DrawDiff Comparison Report

Part number: P-001 | Job: 3366e1c5-ad59-4d1f-a6f4-d53244b1f958 | Generated: 2026-05-05T03:56:19+00:00

ISO_LEFT [MATCHED]

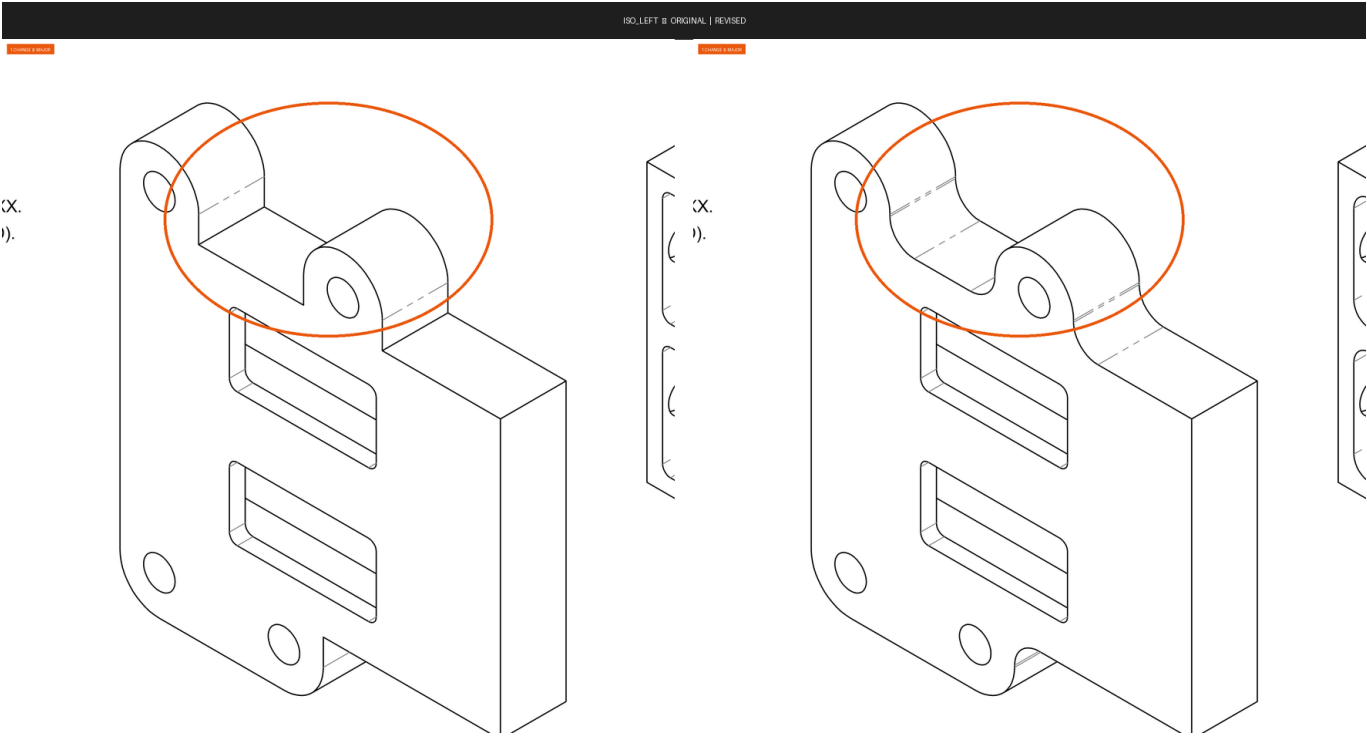
Severity	Field	Zone	Original	Revised	Conf.	Rationale
SIGNIFICANT	geometry	A4	Flat/stepped top surface on hinge bracket arm with sharp shoulder transition between the two cylindrical pivot bosses	Curved/contoured top surface on hinge bracket arm with smooth concave profile connecting the two cylindrical pivot bosses	0.85	The top profile of the central hinge arm between the two pivot bosses changed from a flat stepped geometry to a smooth curved concave cutout, which alters the part geometry, weight, and potentially the stress distribution in that region.

ISO_RIGHT [MATCHED]

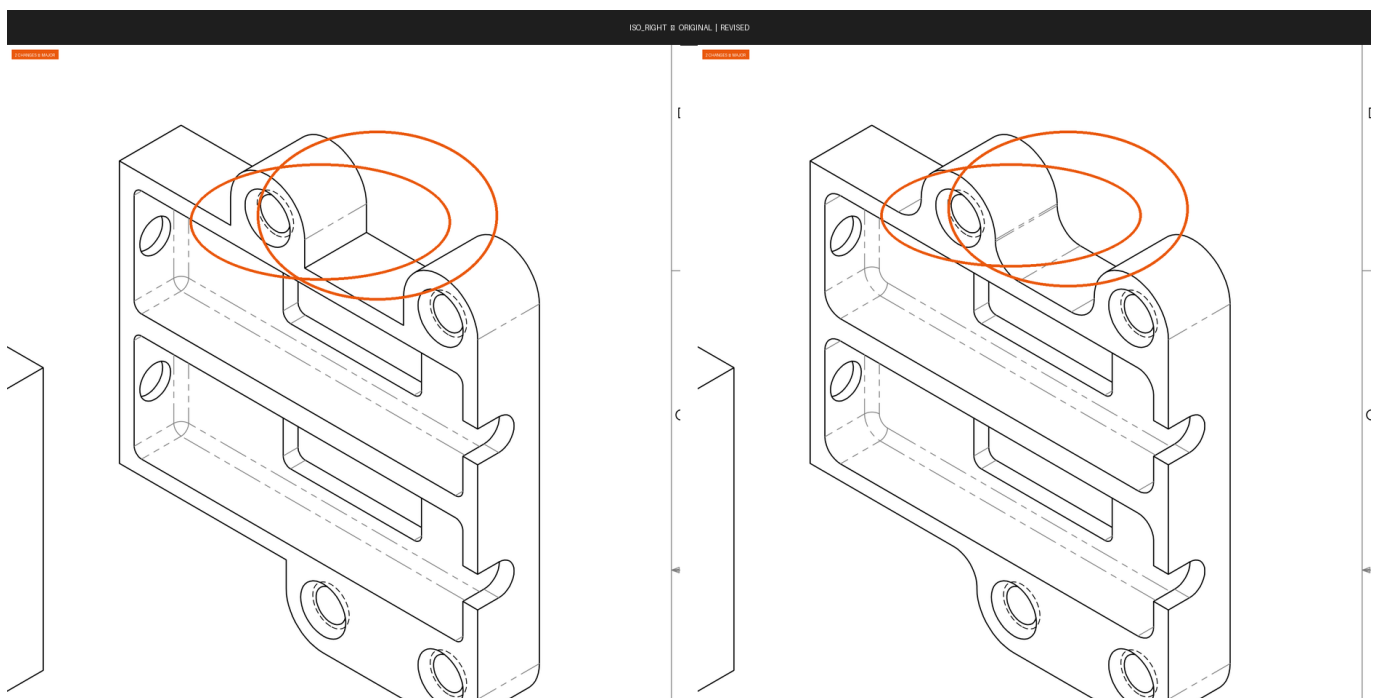
Severity	Field	Zone	Original	Revised	Conf.	Rationale
SIGNIFICANT	feature	A2	Raised/stepped top boss with cylindrical hub visible above upper bracket face (second cylindrical boss present at upper-right of top lug)	Top boss profile reduced; upper-right cylindrical hub feature removed or merged flush — only single central lug boss visible	0.72	The original shows a distinct second raised cylindrical hub on the upper-right of the top clevis/lug area that is absent in the revised view, indicating a geometry change to that boss feature.
SIGNIFICANT	geometry	A2	Upper bracket face has a flat horizontal shelf/step behind the top boss visible as a separate planar face	Upper bracket face behind top boss appears as a smooth curved transition without the distinct flat shelf step	0.70	The step/shelf geometry on the back-top face of the upper section appears modified from a flat step to a concave curved blend, which changes the structural cross-section in that area.

FRONT_VIEW [MATCHED]

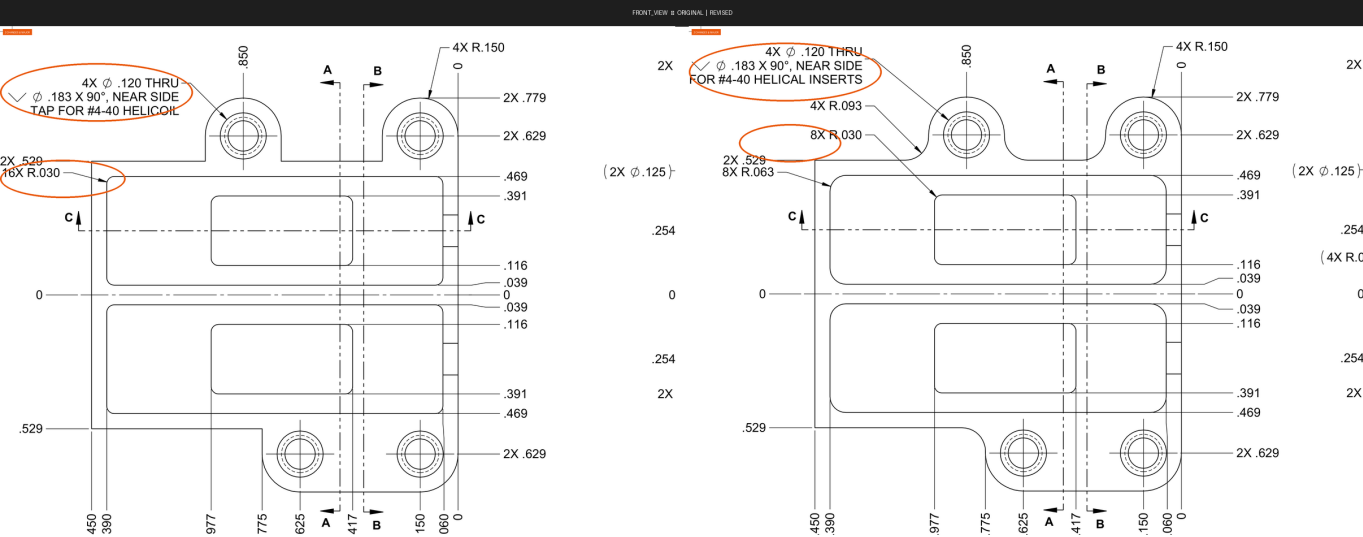
Severity	Field	Zone	Original	Revised	Conf.	Rationale
SIGNIFICANT	note	A6	TAP FOR #4-40 HELICOIL	FOR #4-40 HELICAL INSERTS	0.92	The thread insert callout wording changed from 'TAP FOR #4-40 HELICOIL' to 'FOR #4-40 HELICAL INSERTS', reflecting a change in insert specification or brand reference that affects manufacturing process.
SIGNIFICANT	annotation	A6	16X R.030	8X R.030	0.90	The count of R.030 radii changed from 16X to 8X, indicating fewer corner radii of this size are now specified on the part.

SECTION A-A [MATCHED]

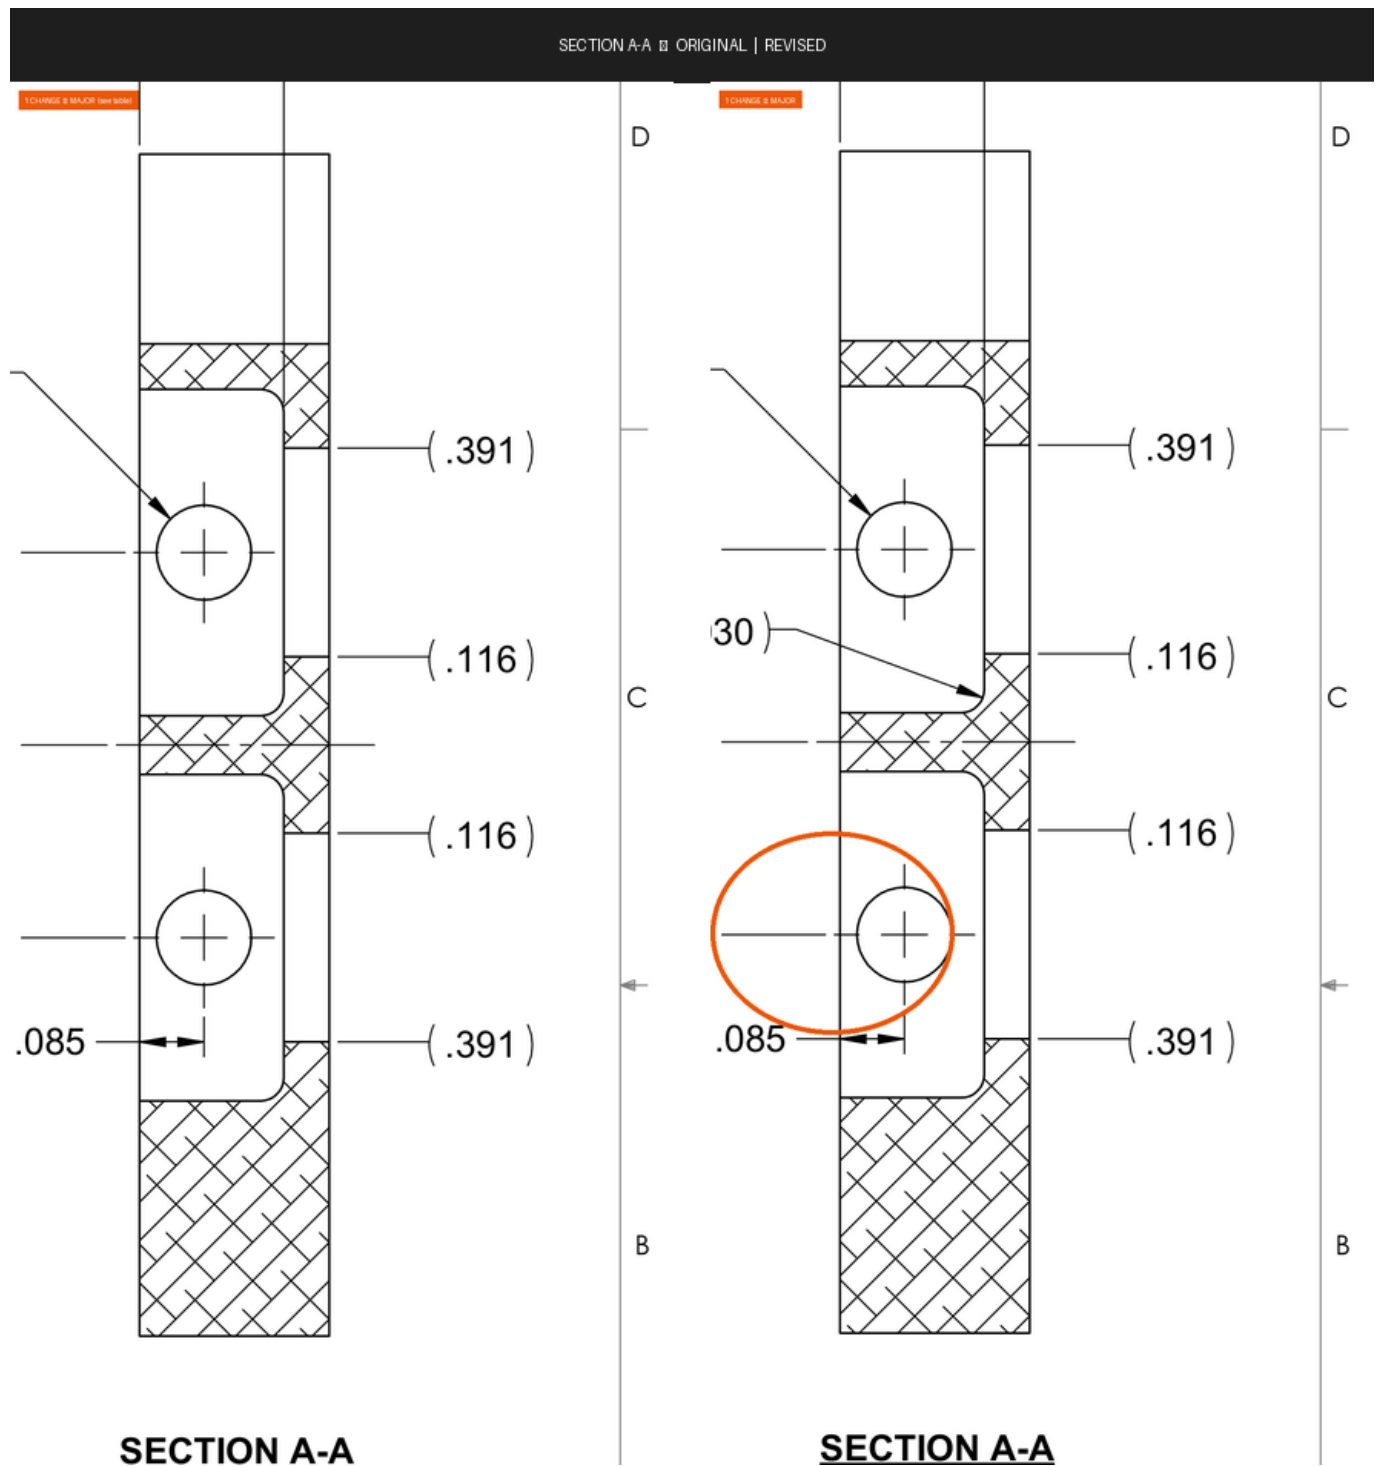
Severity	Field	Zone	Original	Revised	Conf.	Rationale
SIGNIFICANT	annotation	B2	—	(.30)	0.82	A new reference dimension callout '(.30)' with a leader arrow pointing to the fillet/radius feature at the step between the upper bore and the shoulder has been added in the revised drawing; this annotation did not exist in the original and defines a previously uncalled-out geometry.

SECTION C-C [MATCHED]

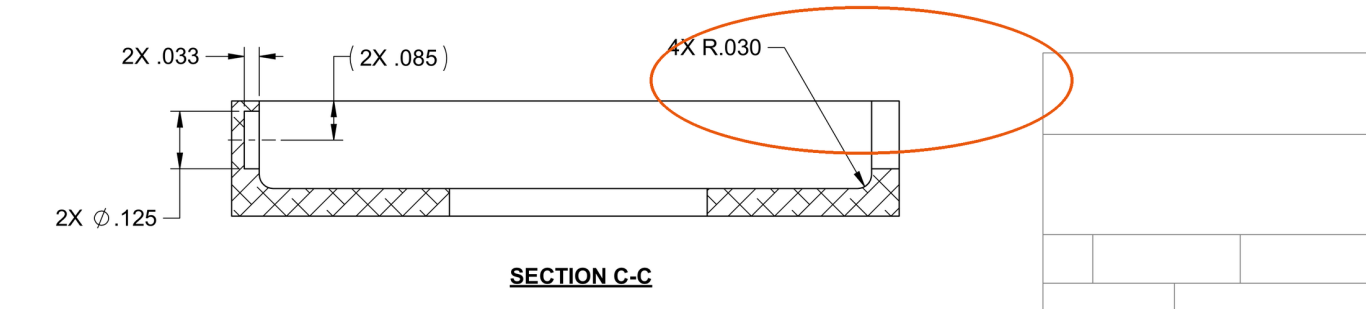
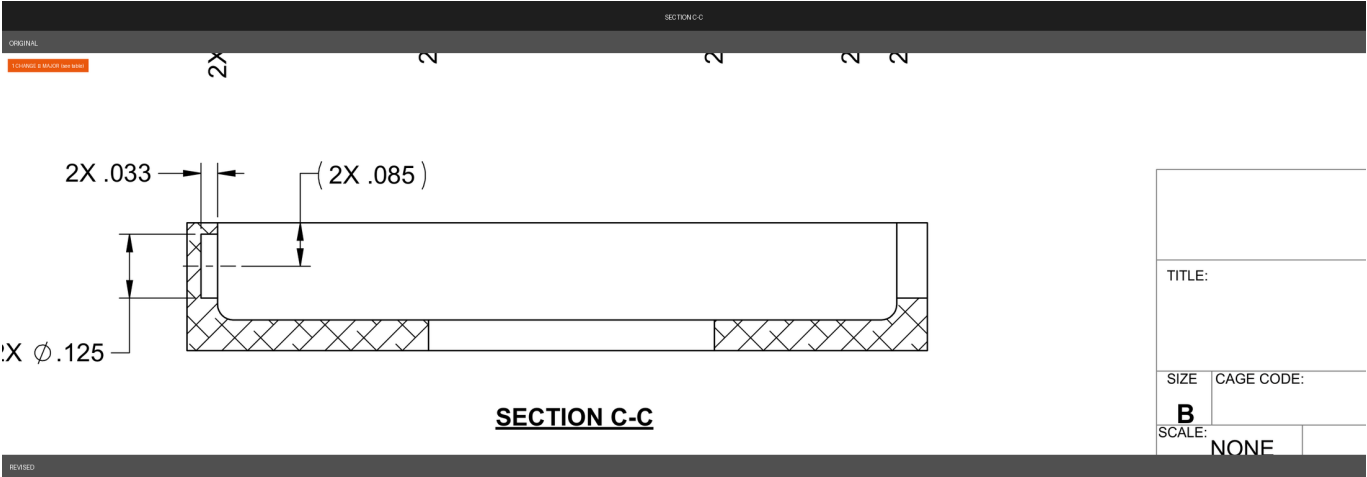
Severity	Field	Zone	Original	Revised	Conf.	Rationale
SIGNIFICANT	callout	D3	—	4X R.030	0.95	A new corner radius callout '4X R.030' has been added in the revised drawing, specifying four corner radii of 0.030 inches that were not previously called out, which affects the machined geometry of the part.
